ADDENDUM NO. 2

FEBRUARY 28, 2024

Staunton City Public Schools, VA
Shelburne Middle School Additions and Renovations
CRA Project No. 3636

KEYNOTES

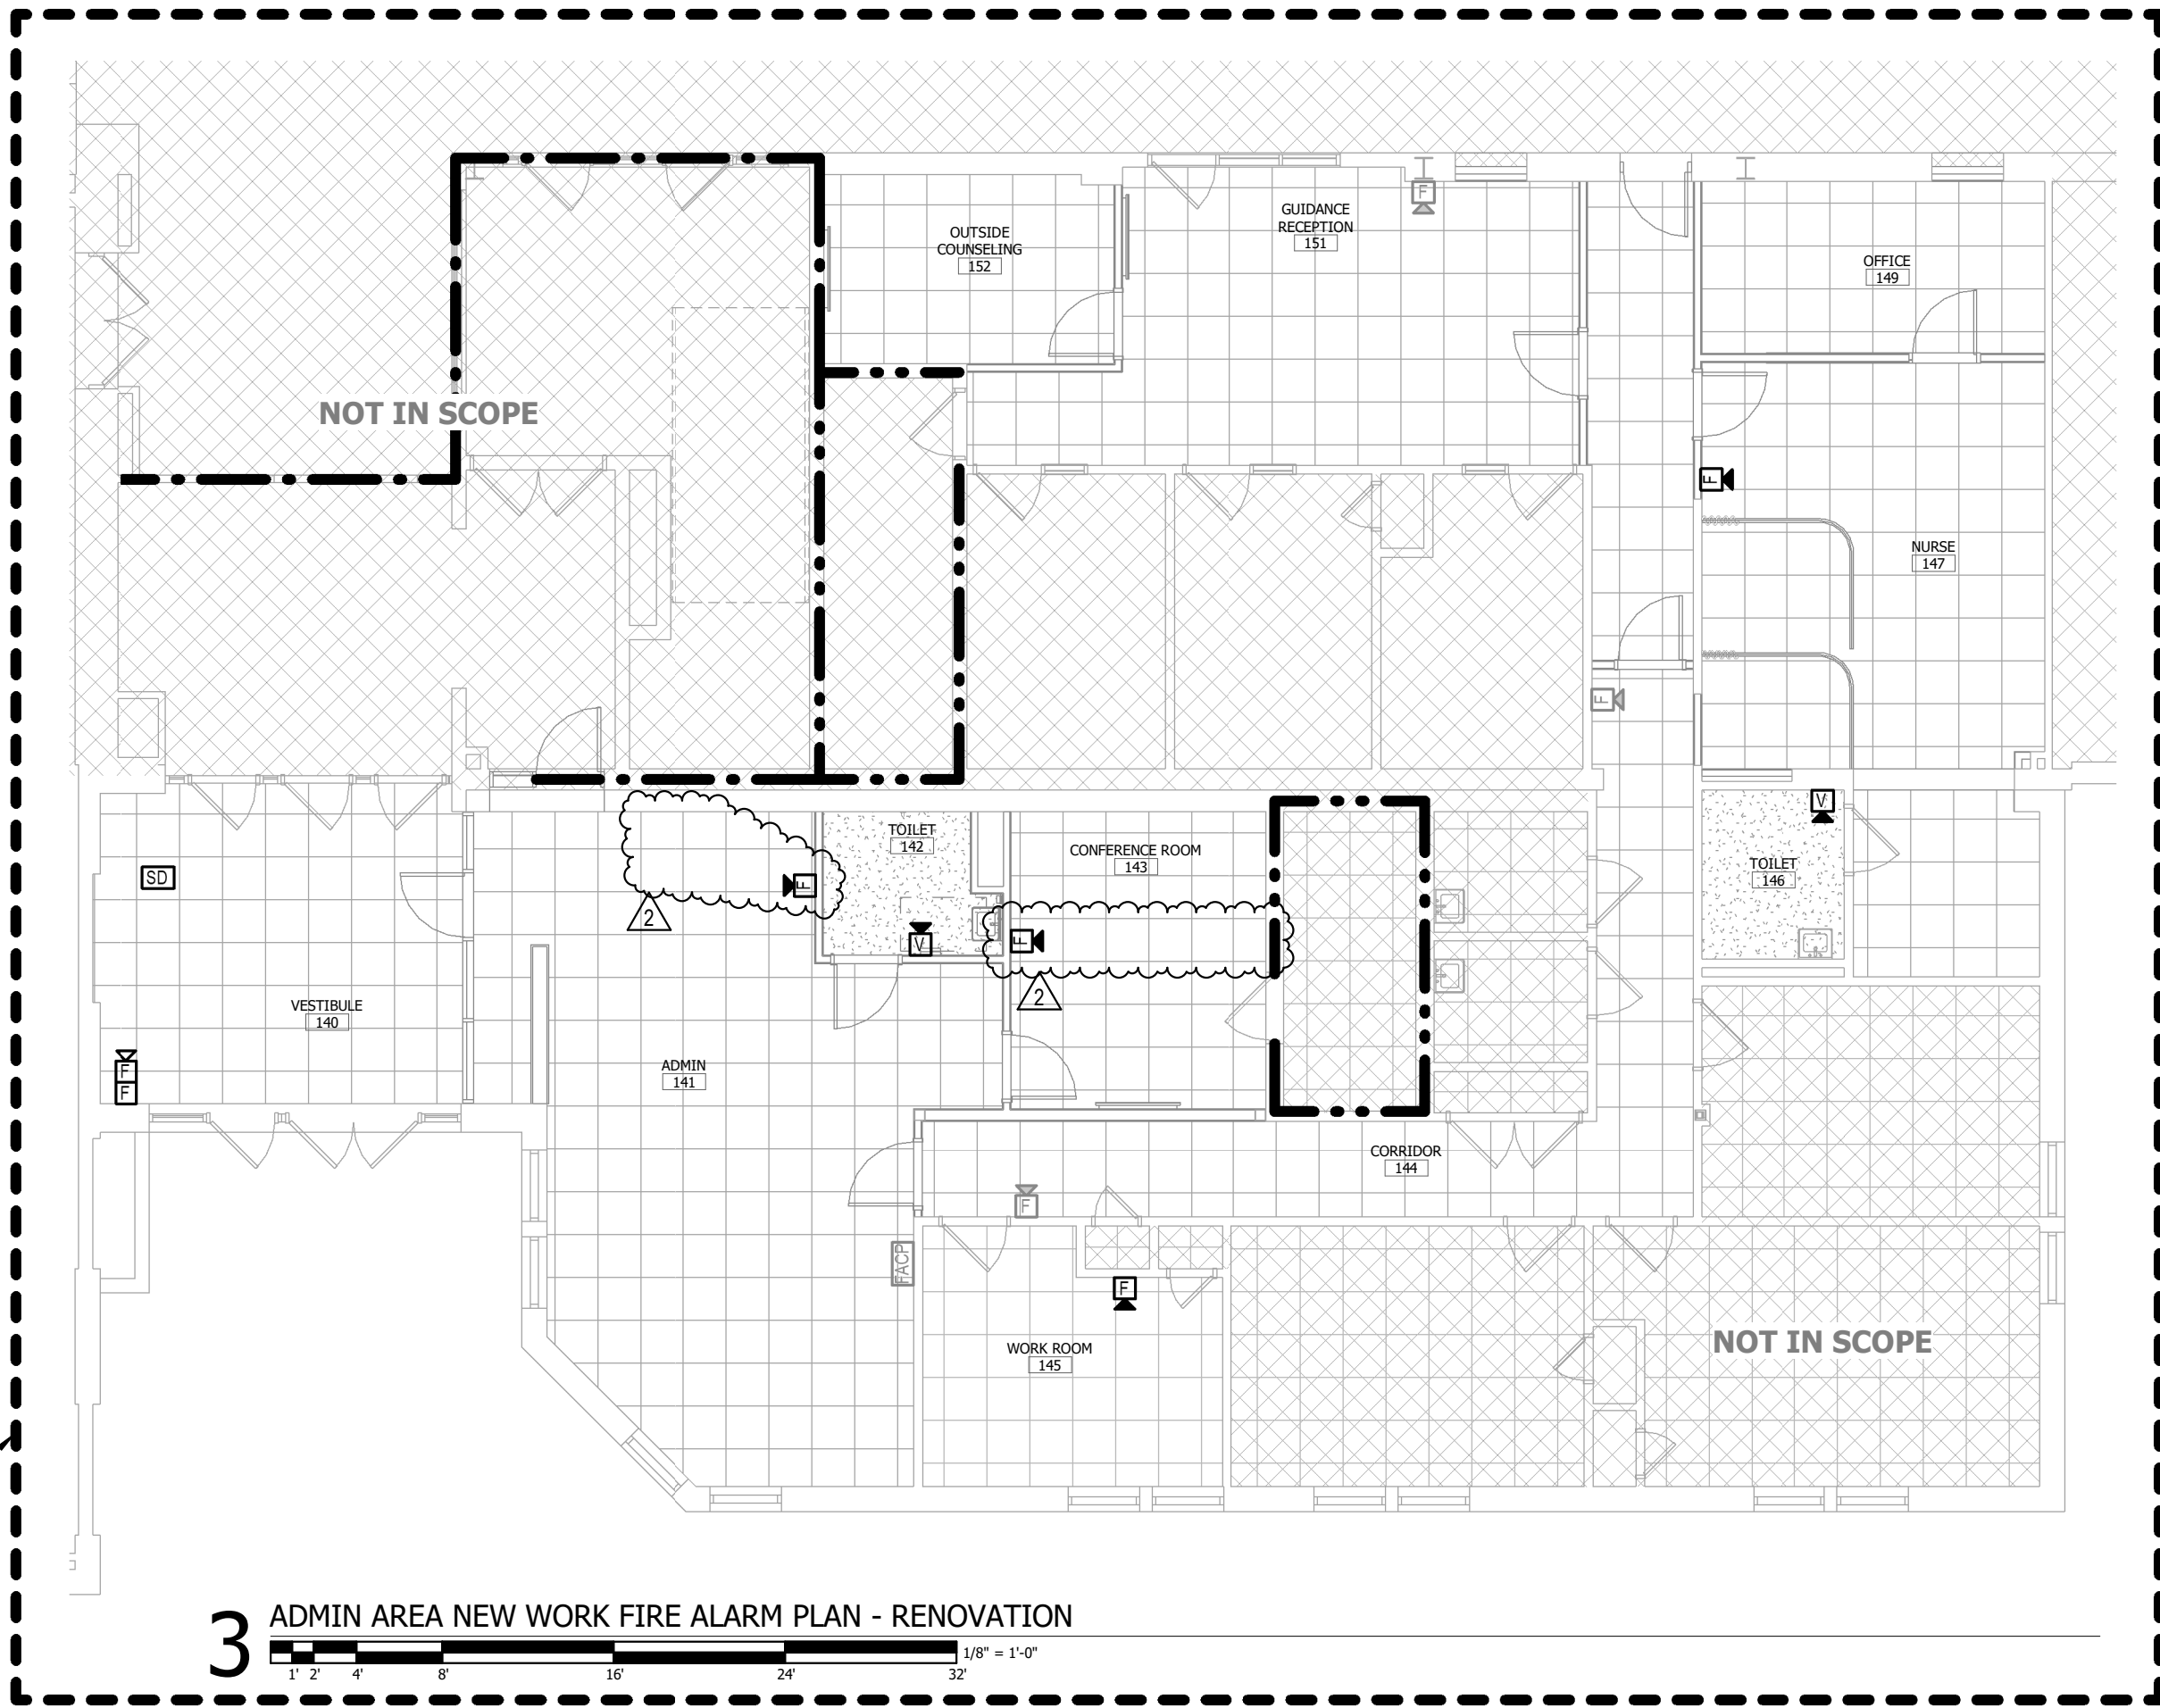
1. **DELETE** this sheet in its entirety and **REPLACE** with the attached sheet.
 - a. **REVISE** locations of notification devices in Admin 141 and Conference 143.

ED1.1

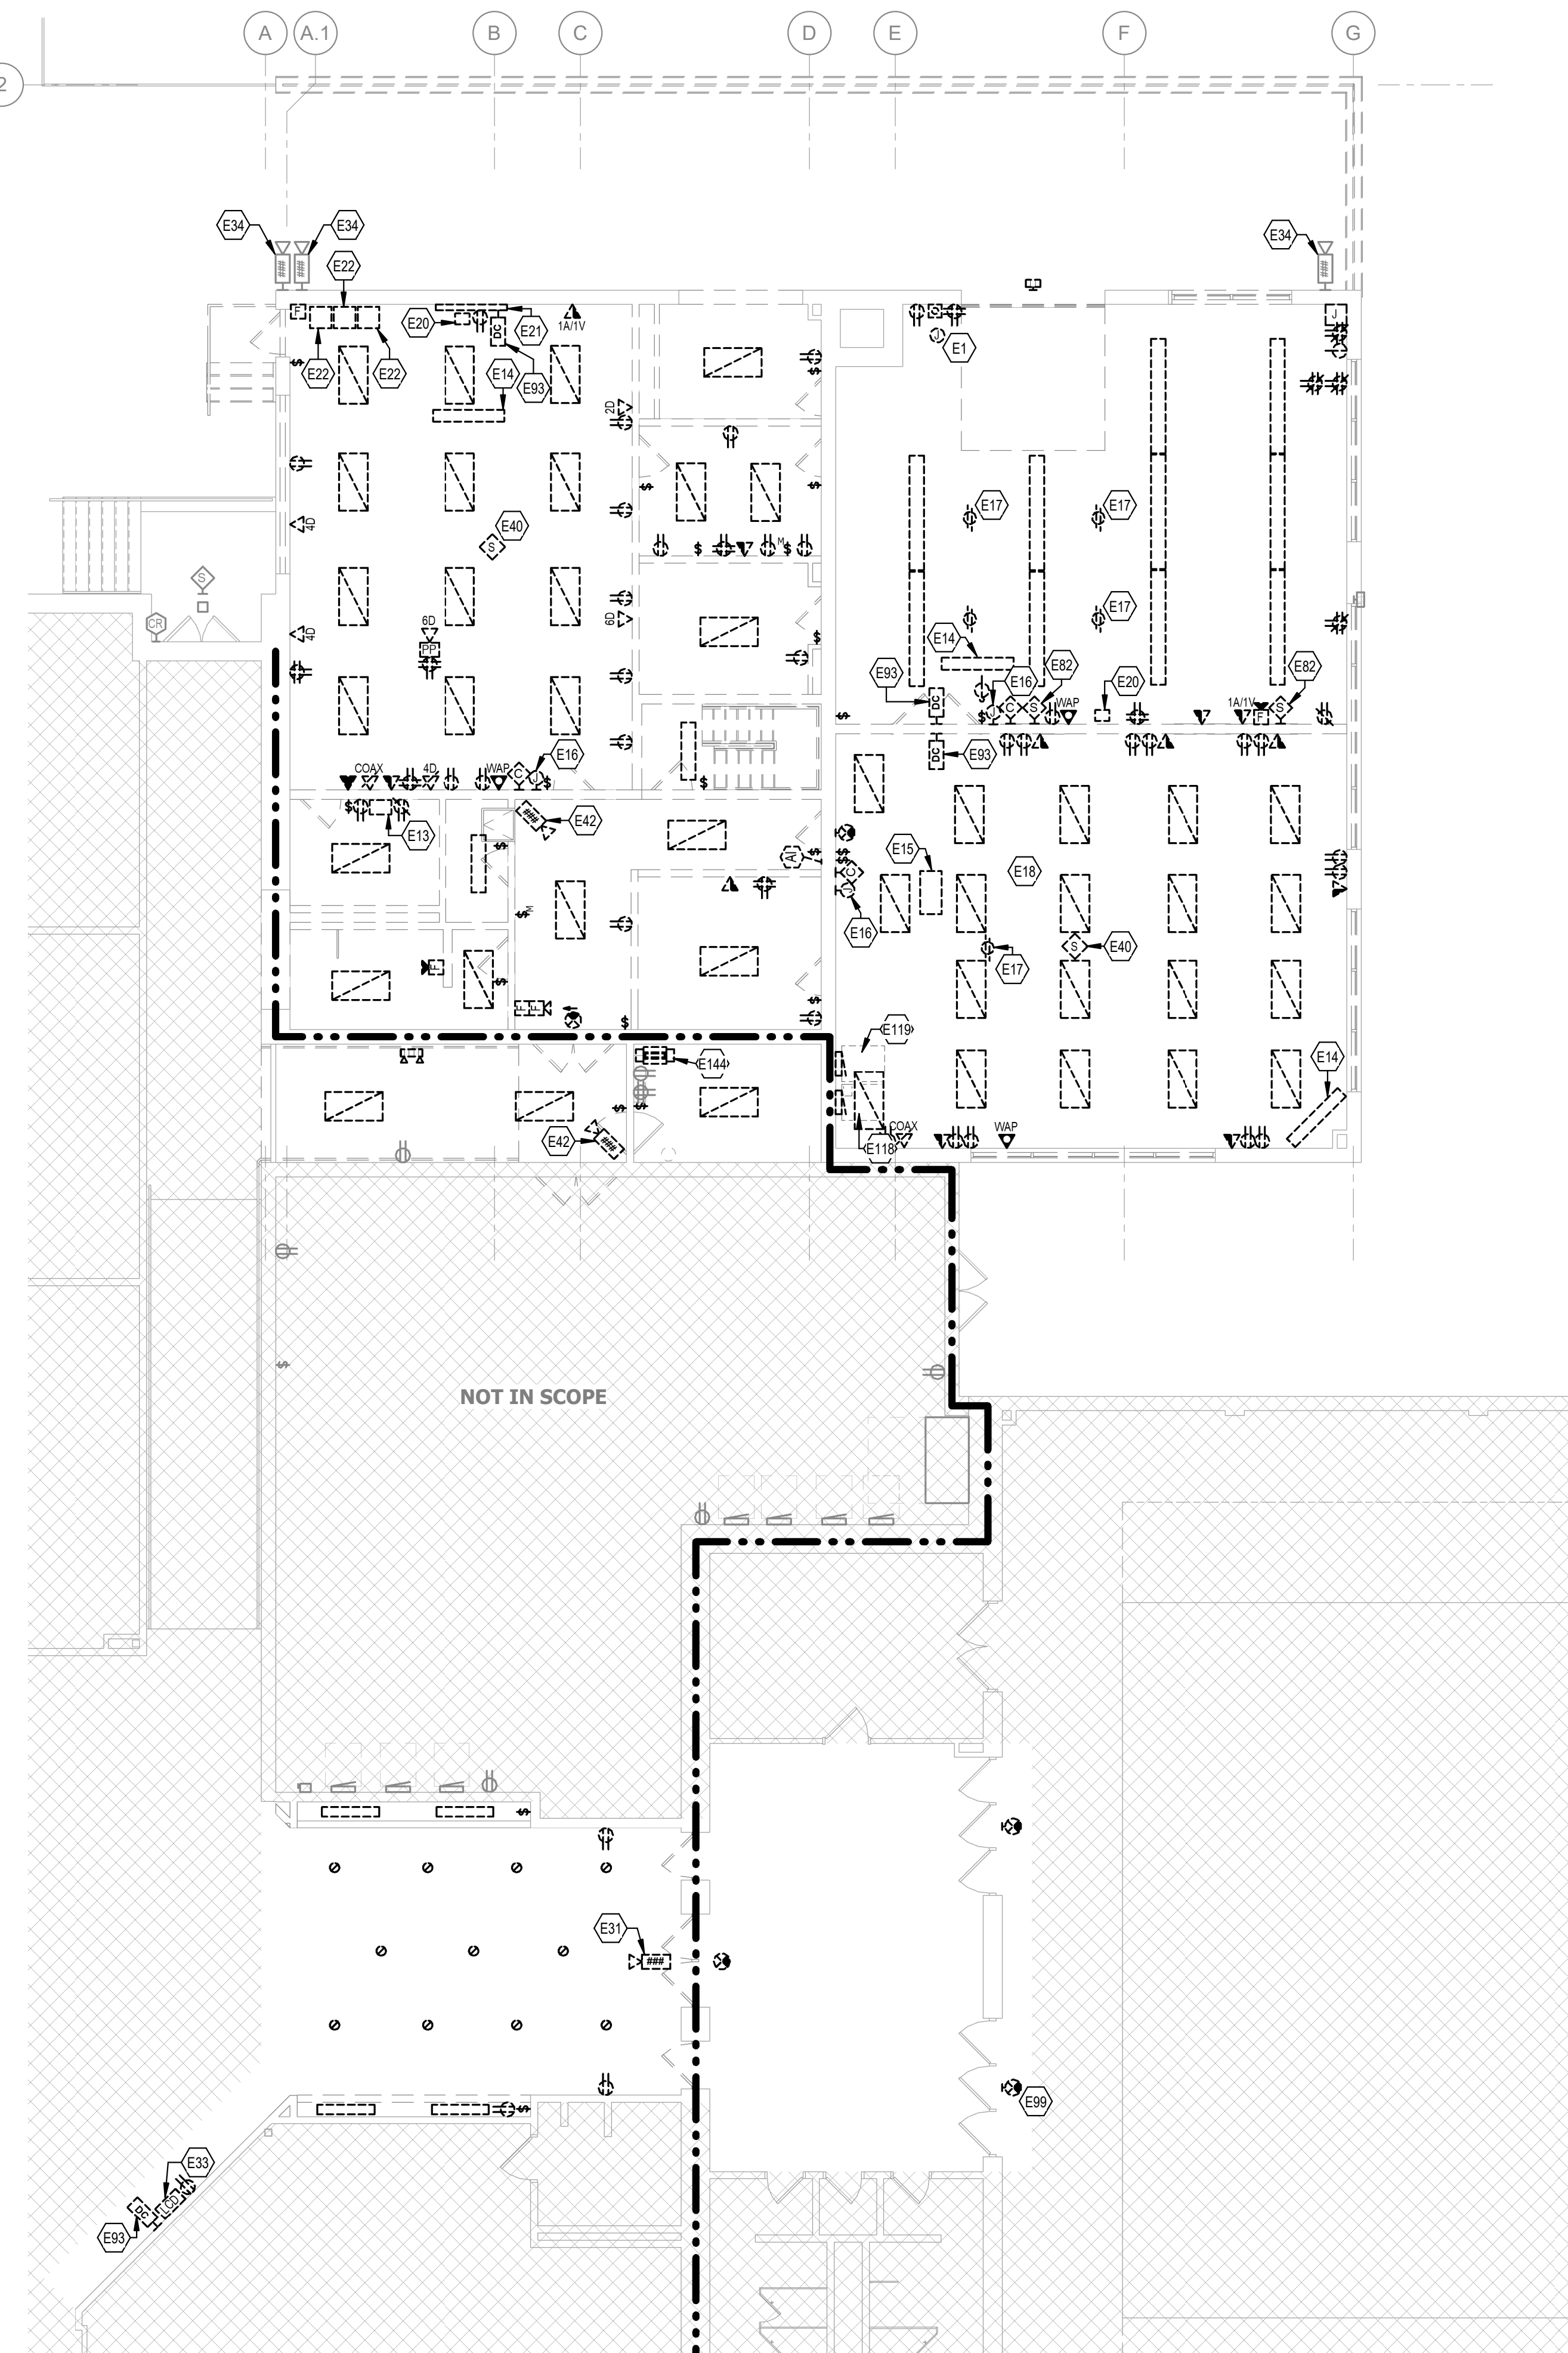
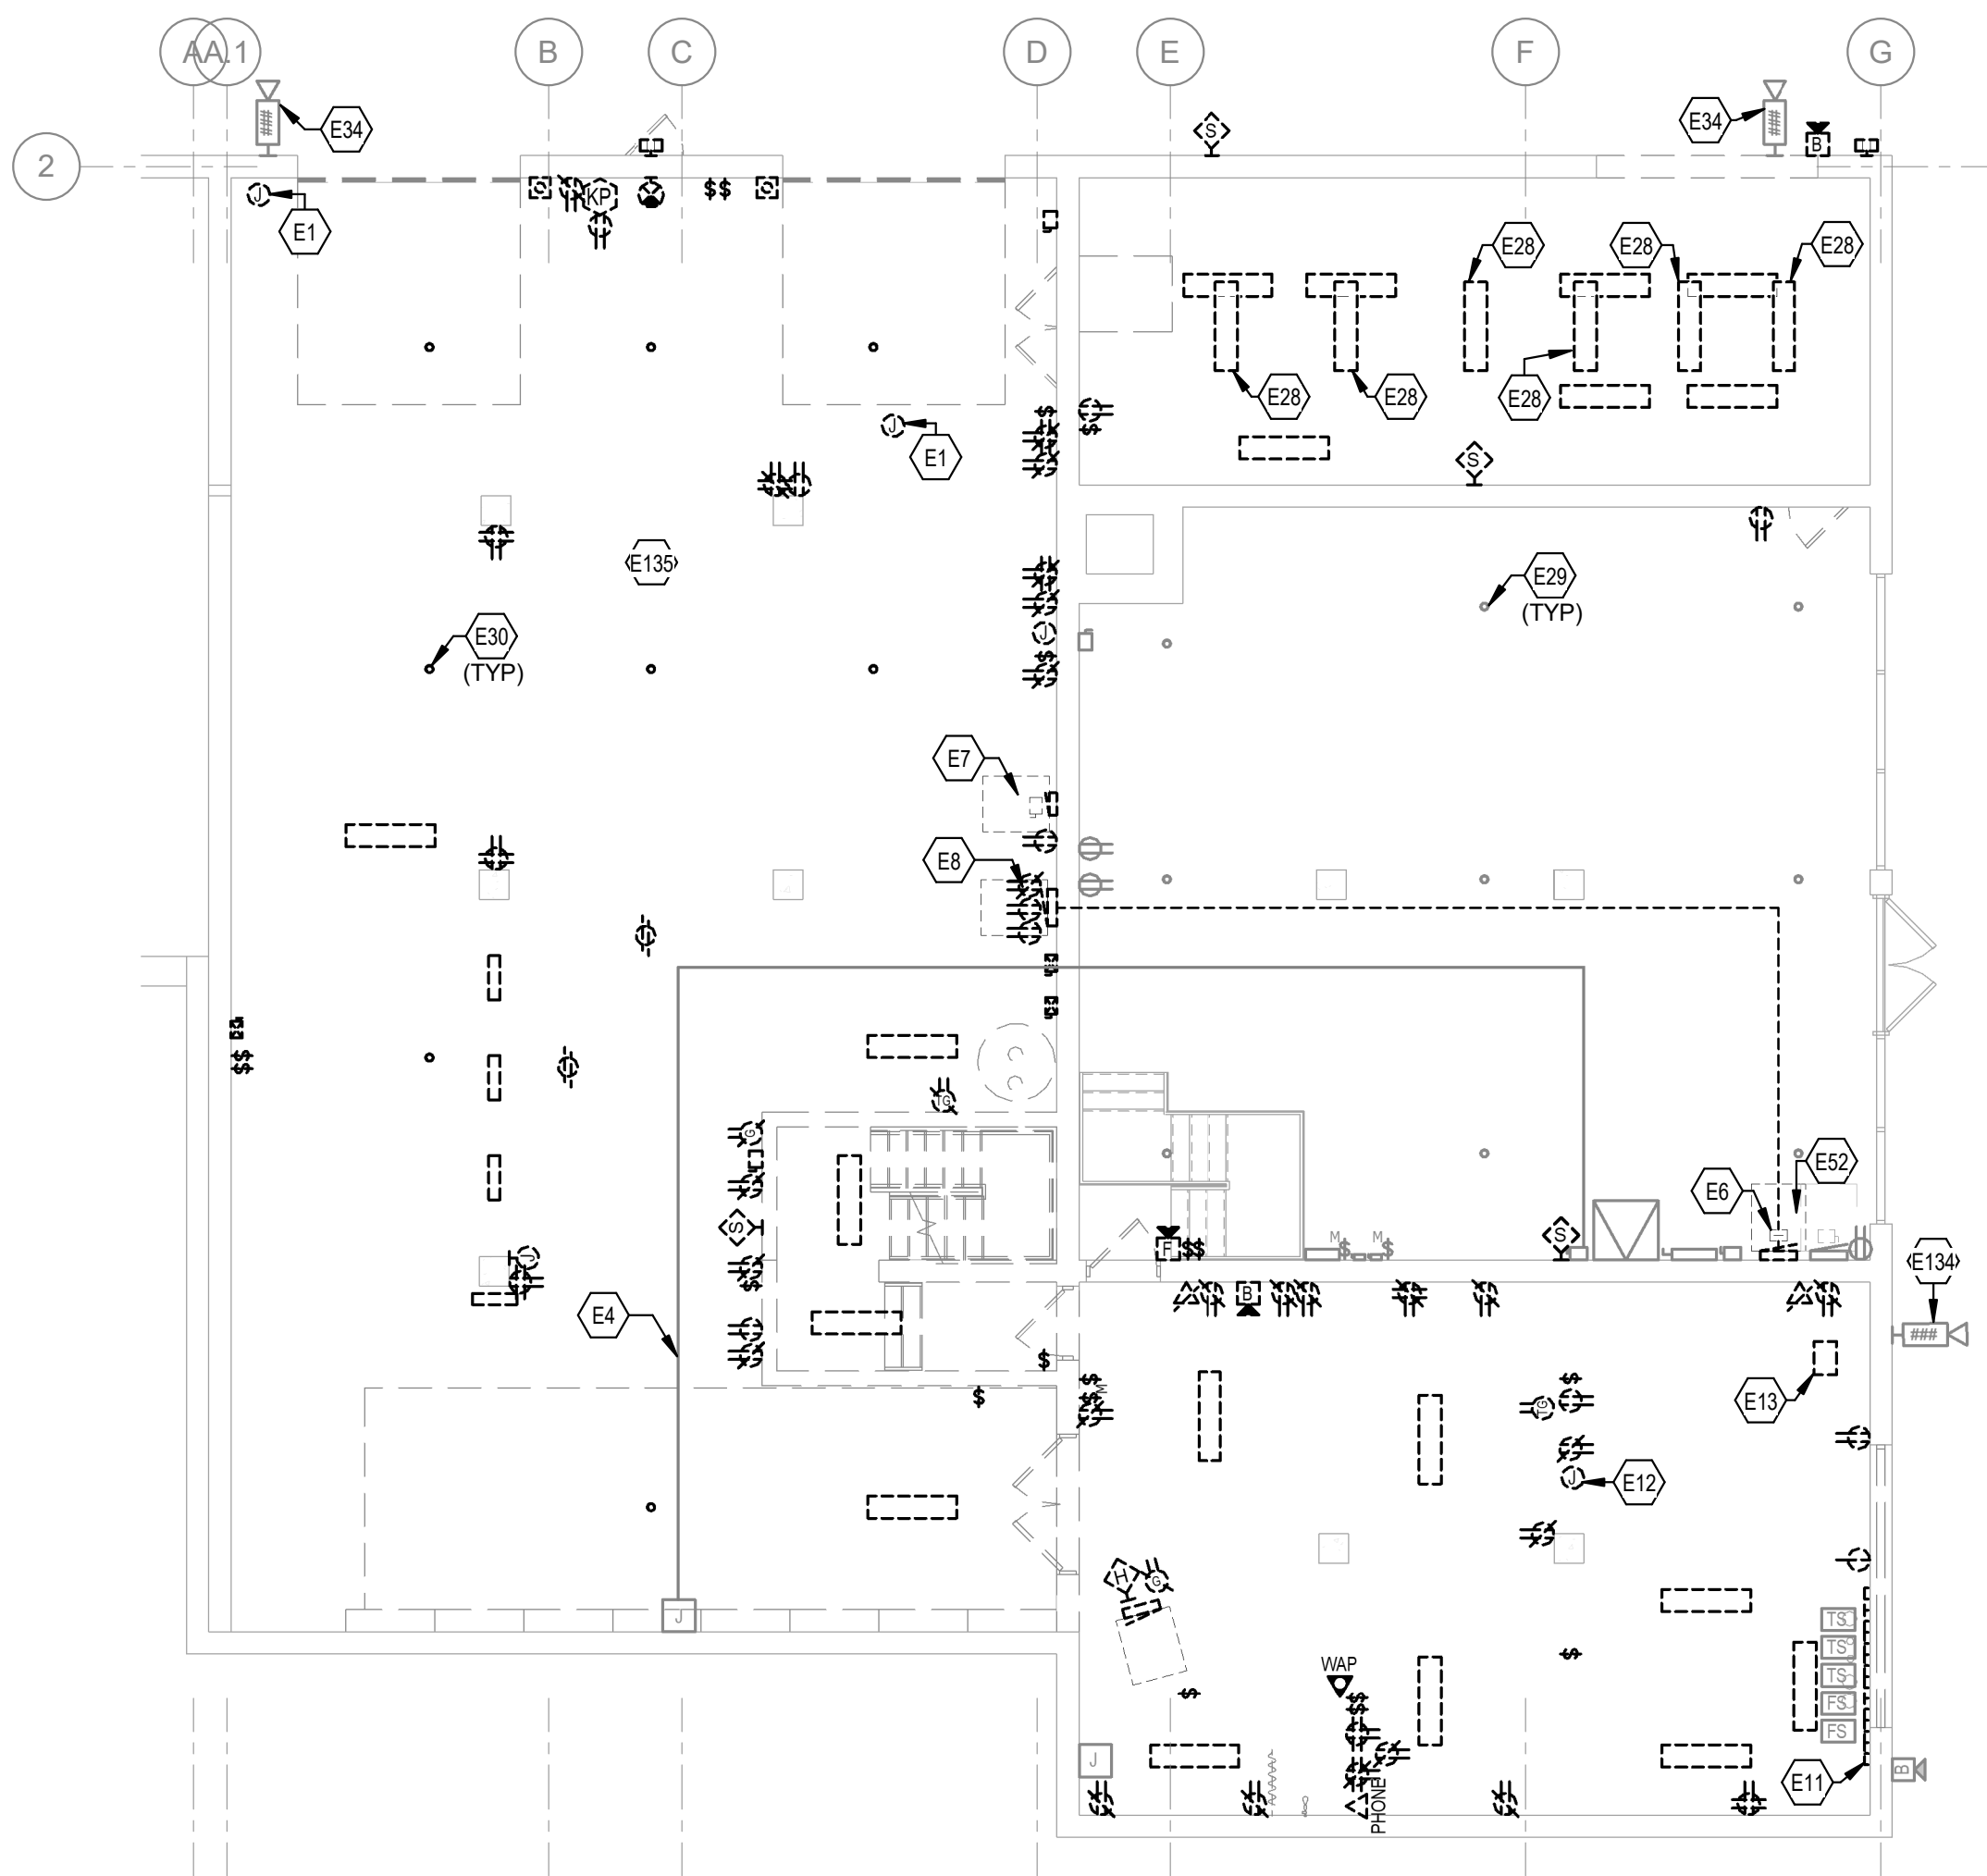
1. **DELETE** this sheet in its entirety and **REPLACE** with the attached sheet.
 - a. **ADD** keynotes E180 and E181 to clarify existing/demo conditions in admin area.
